Item ID: D3183-045 Accept ***N900040100*** Setup Start ***NS1***
 Revision ID: Stop ***NS2***
 Item Name: Bearing Assembly
 Start Date: 6/24/2016 Start Qty: 20.00 ***20*** Cust Item ID:
 Required Date: 6/30/2016 Req'd Qty: 20.00 ***20*** Customer:
 Reference:

DESIGN #	DRAWN BY CP	DART AEROSPACE LTD HAWKESBURY, ONTARIO, CANADA	
CHECKED #	APPROVED #	DRAWING NO. D3183	REV. C SHEET 1 OF 4
DATE 04.02.17		TITLE BRACKET ASSEMBLY	SCALE 1:1
A.	03.01.24	NEW ISSUE	
B.	03.06.17	REMOVE BEARING; 1.012 WS 0.882	
C.	04.02.17	ADD -045/-9; 0.182 WAS 0.431	
CI	04.11.09	0.830 WAS 0.850

DRAWING NO. D3183	TITLE BRACKET ASSEMBLY	REV.C1	DART AEROSPACE LTD ENGINEERING ORDER		D.E.O. NO. D3183-C1-1	SHEET NO. SHEET 1 OF 1	SCALE NTS
DRAWN <i>WP</i>	CHECKED <i>WP</i>	MFG. APPR. <i>WP</i>	APPROVED <i>WP</i>		DE APPR. <i>WP</i>		
DATE 10.05.14	DATE 10.06.30	DATE 10.06.30	DATE 10/06/30		DATE 10/06/30

D3183-5 BEARING:
SPECIFICATION CONTROL DRAWING

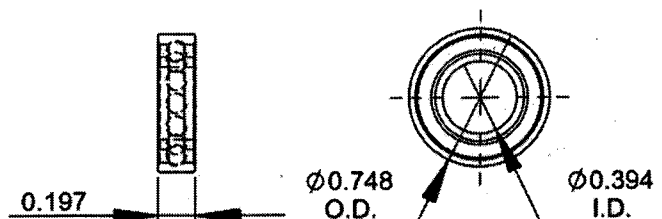
ADD POSSIBLE SUPPLIER: KML P/N 6800-ZZ

BASIC LOAD RATING REQUIREMENT: Cr = 1720 N (386 lb) MIN [DYNAMIC]
Cor = 840 N (188 lb) MIN [STATIC]
